# VIDAL HOUSE

**VIDAL HOUSE**  
REMODEL/ADDITION  
4958 PINE ST  
LA MESA, CA 91942

### CONSTRUCTION CHANGE - SCOPE OF WORK

REVISION	DATE
CONSTRUCTION CHANGE ADD 50 SF	01/09/18

**FLOOR PLAN**  
DEMO/  
PROPOSED

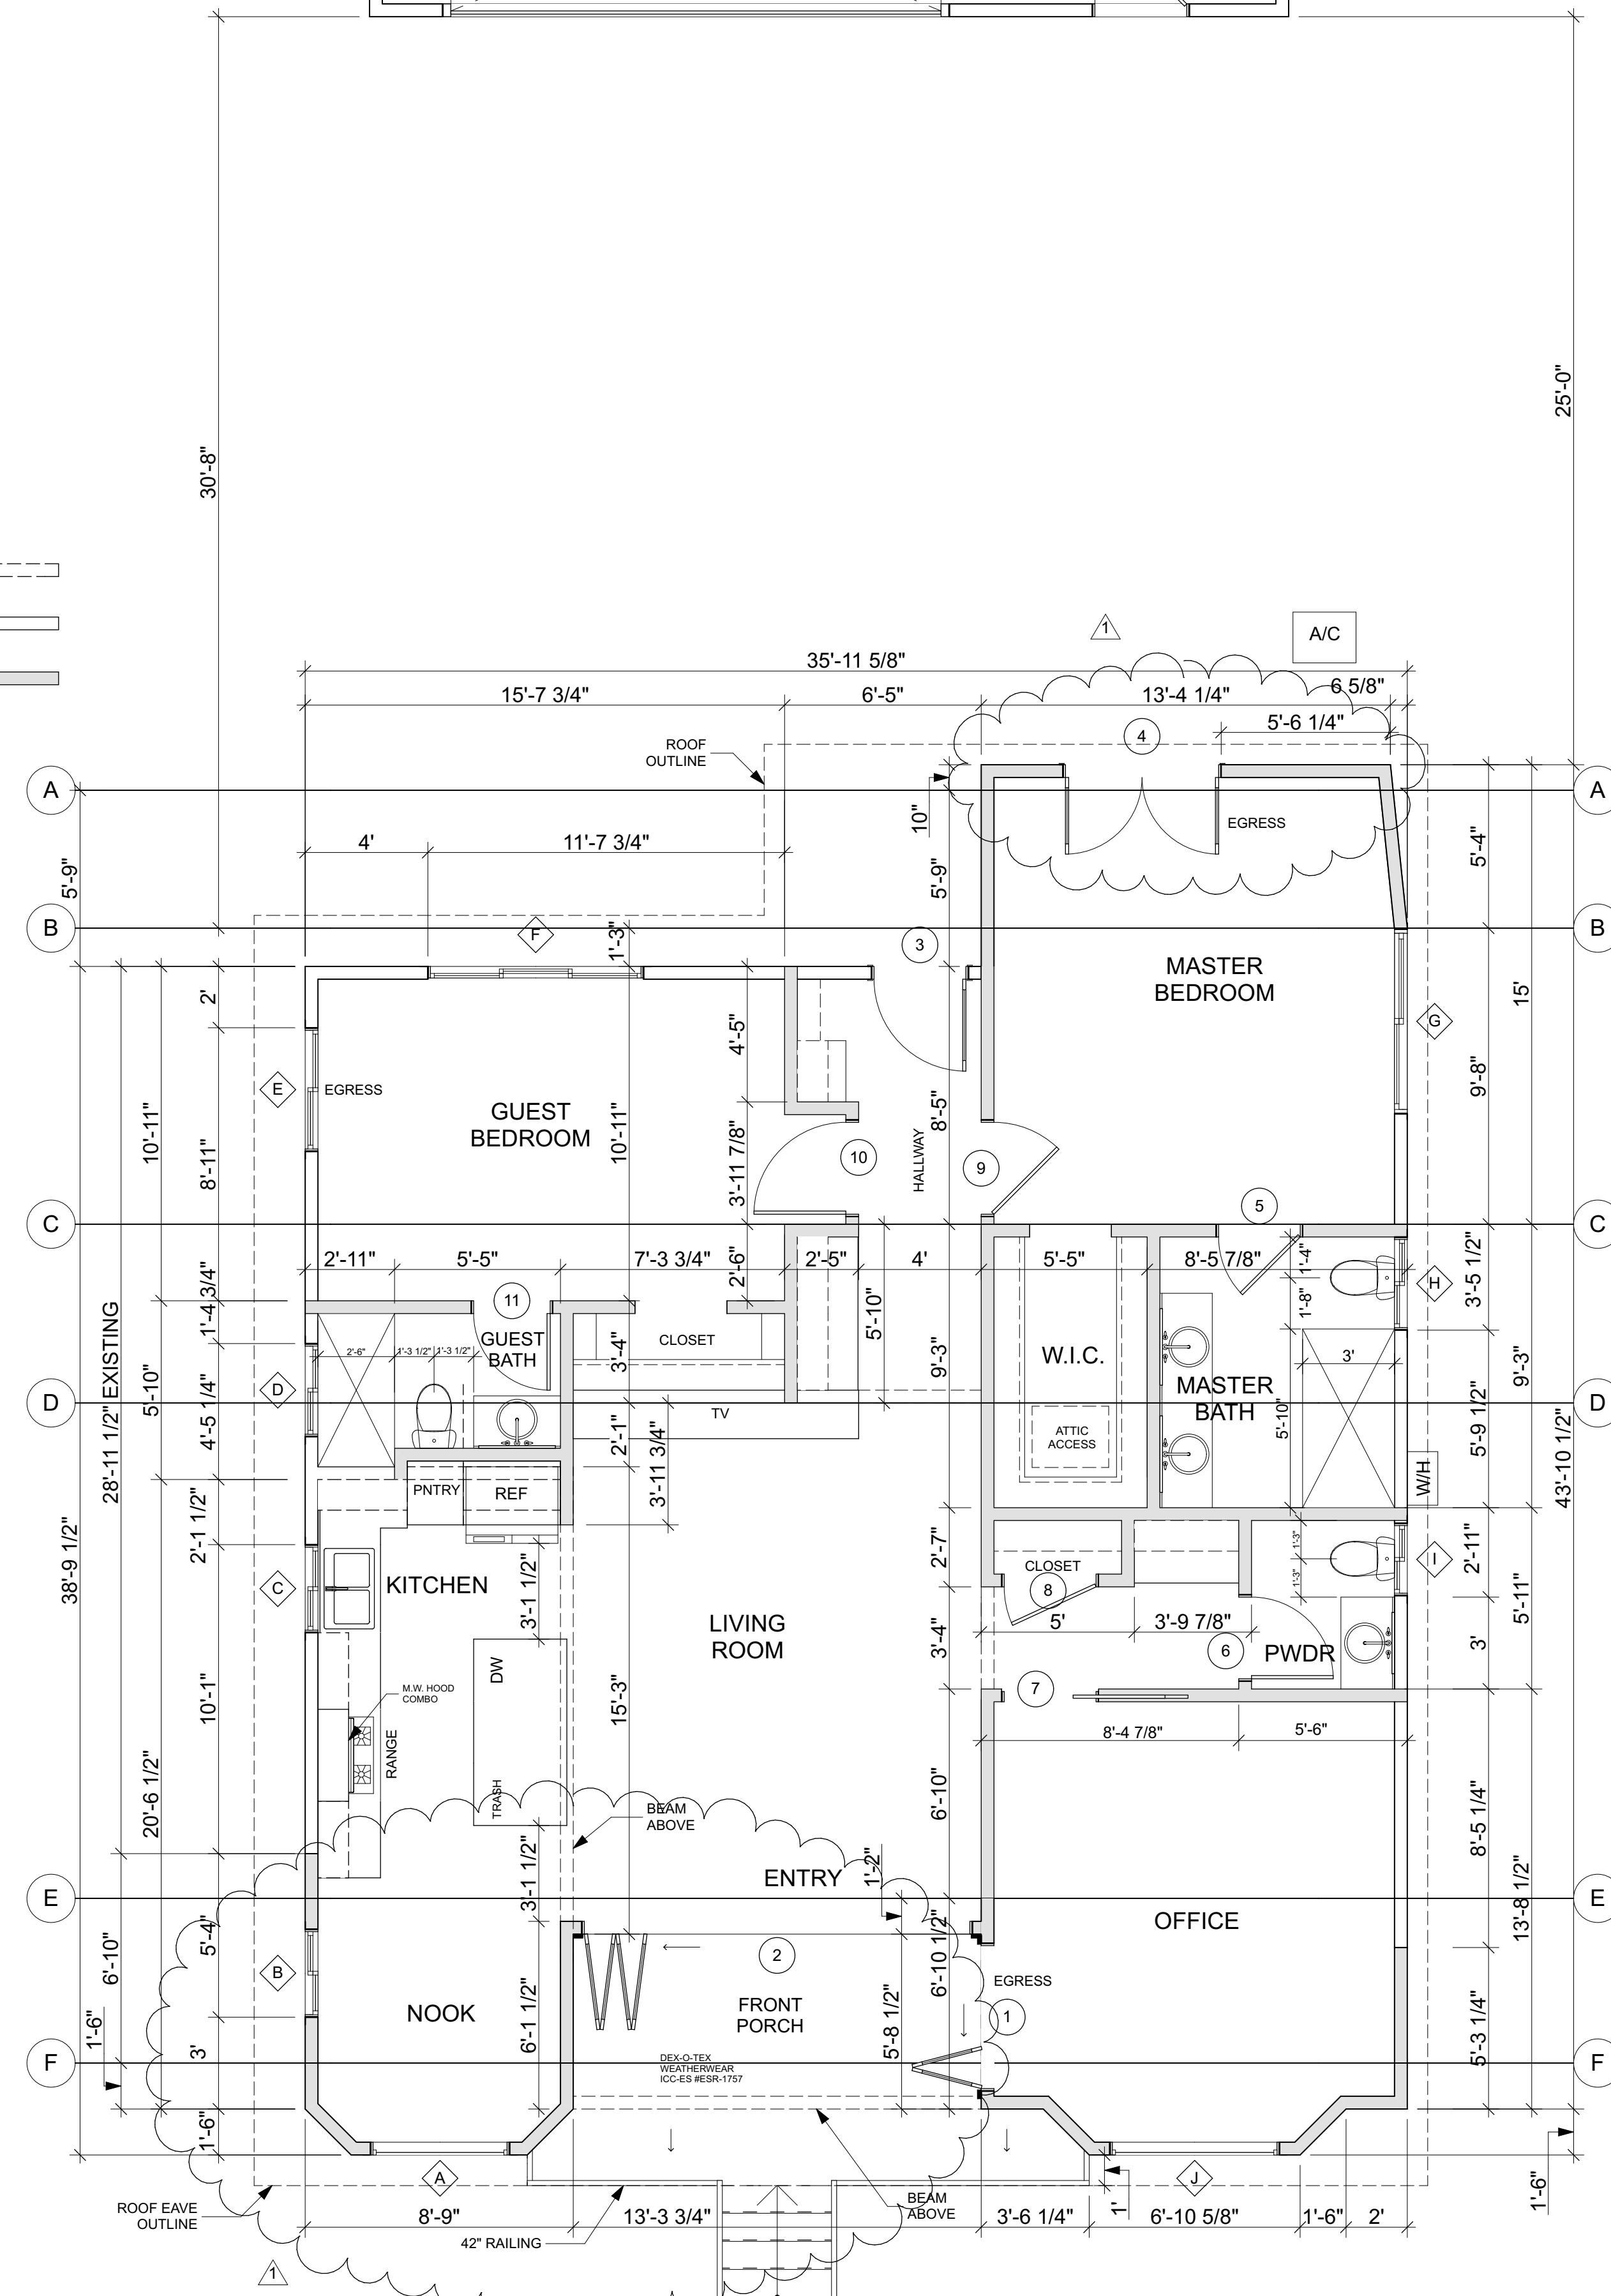
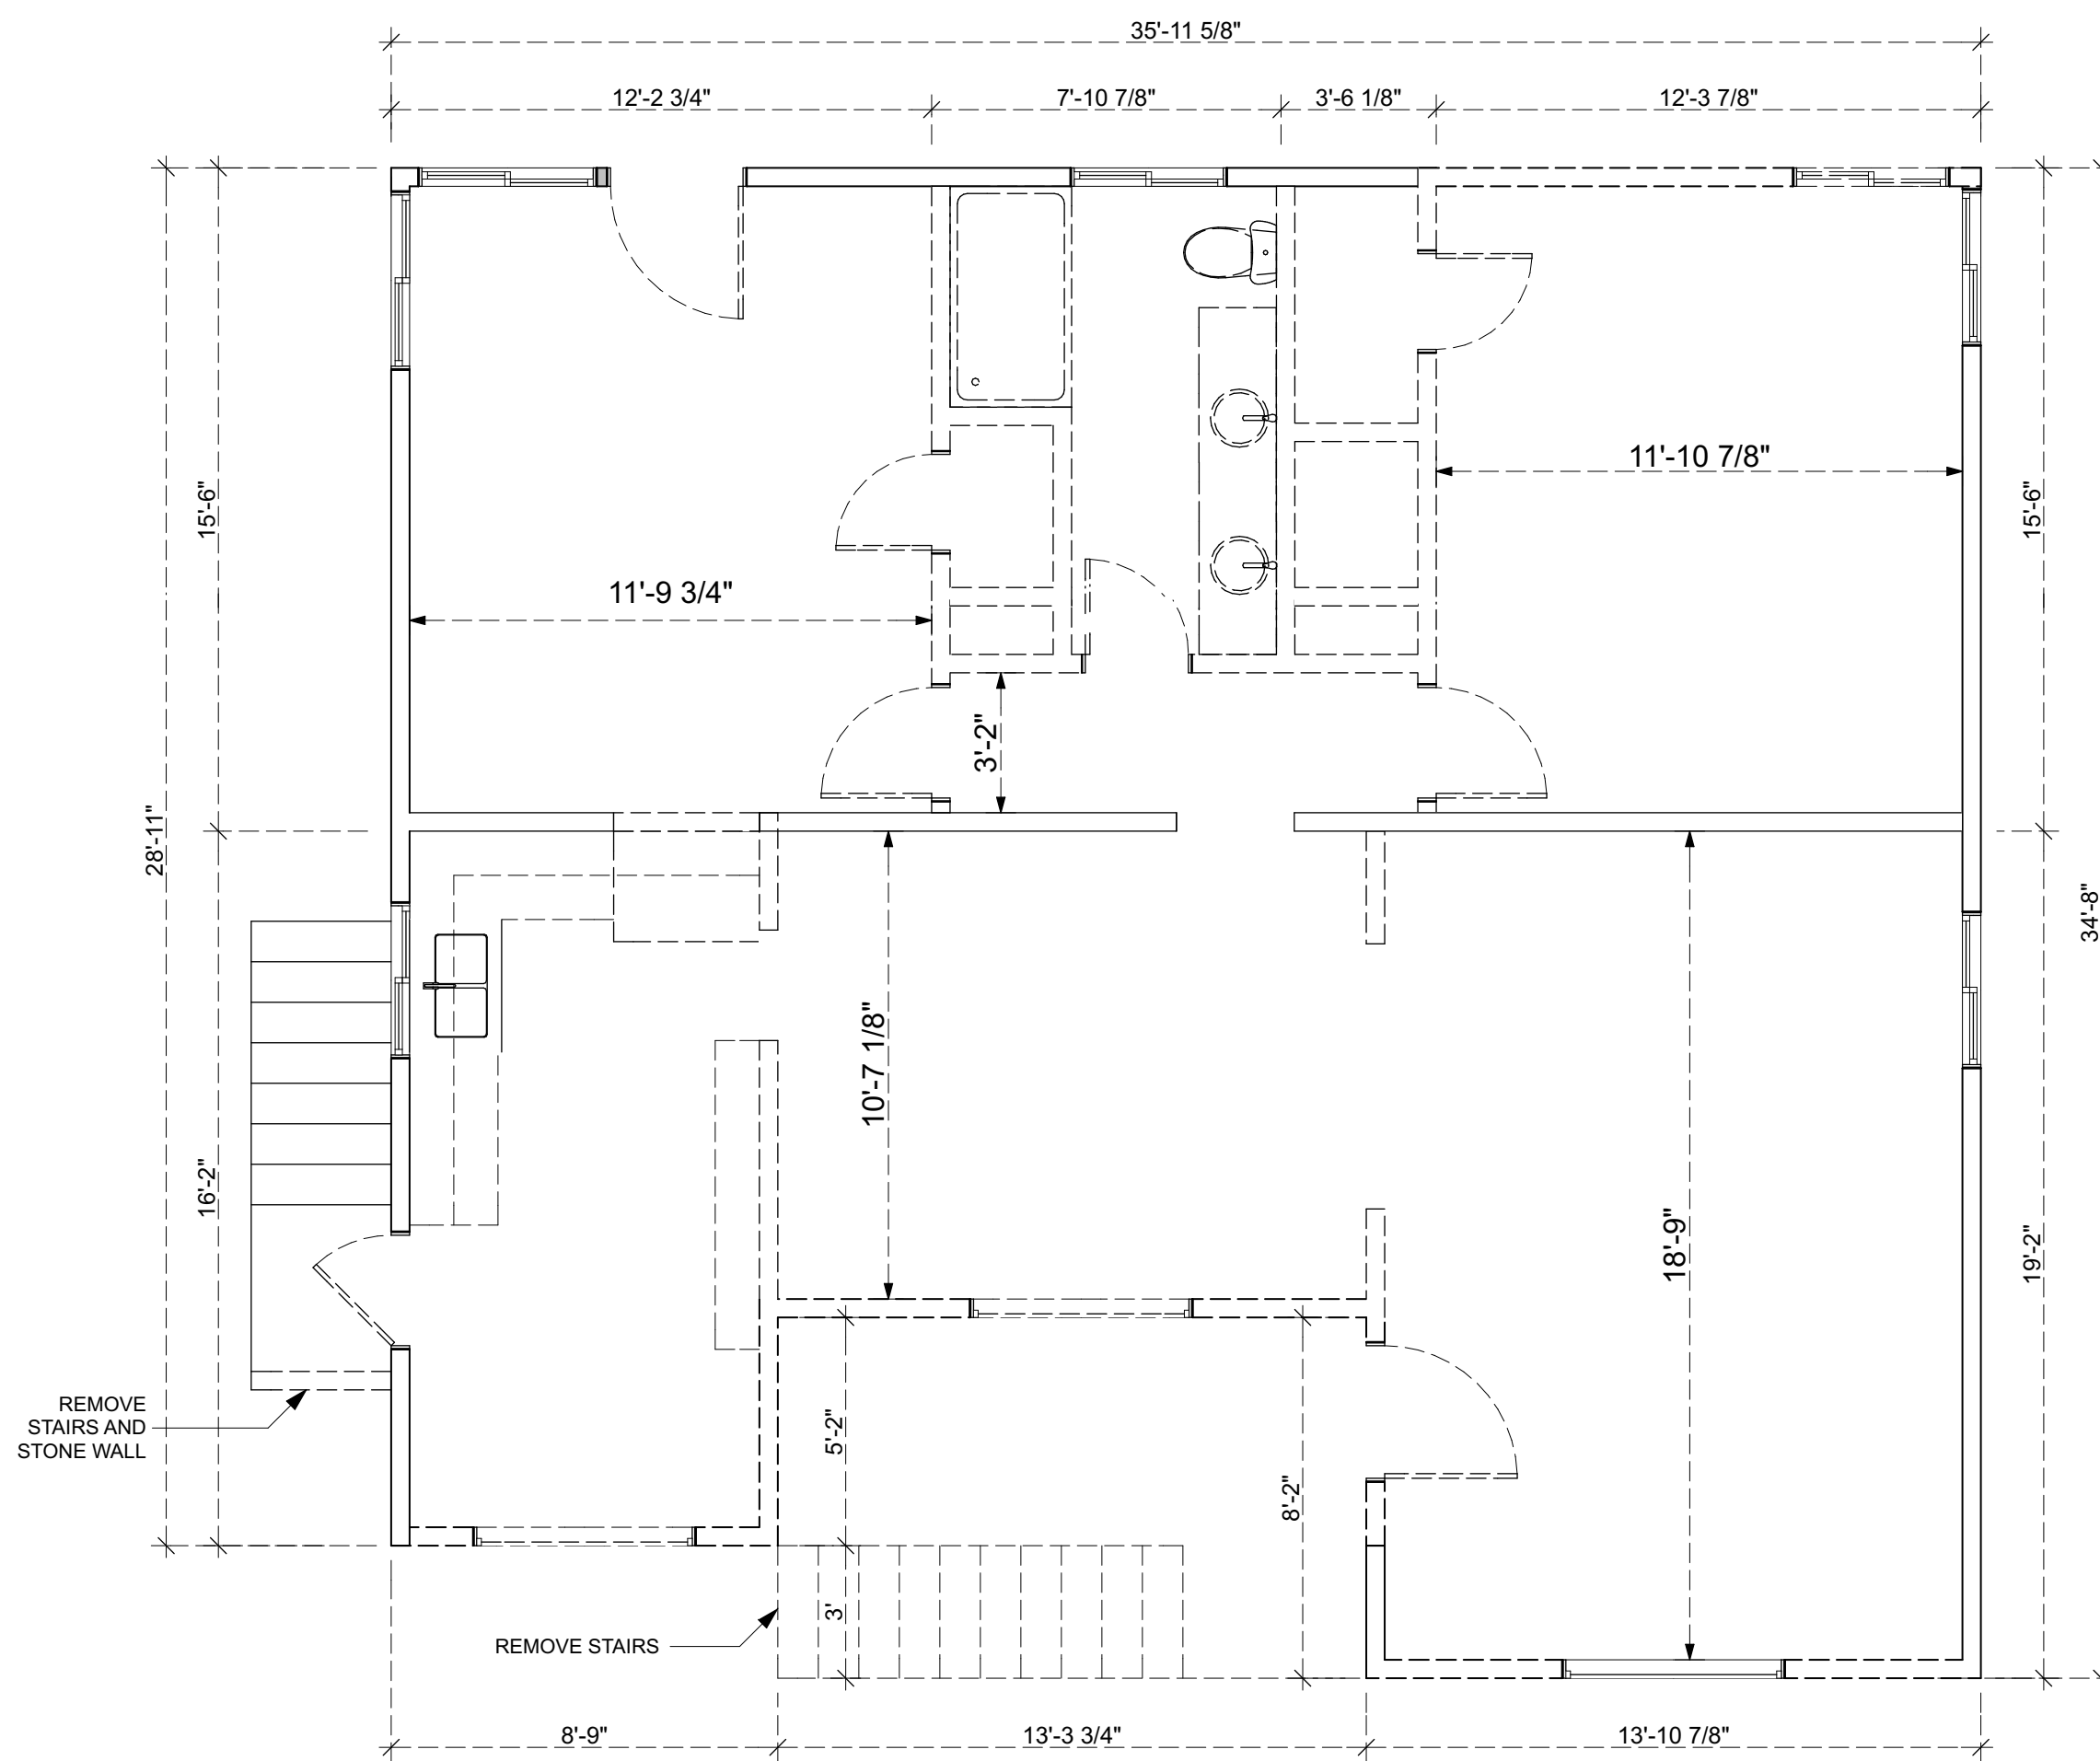
Add 50 SF by pulling out the nook 3'-0",  
and pushing out the master bedroom 10"  
Also, change the location of the AC and Water Heater  
and update existing dimensions per demo
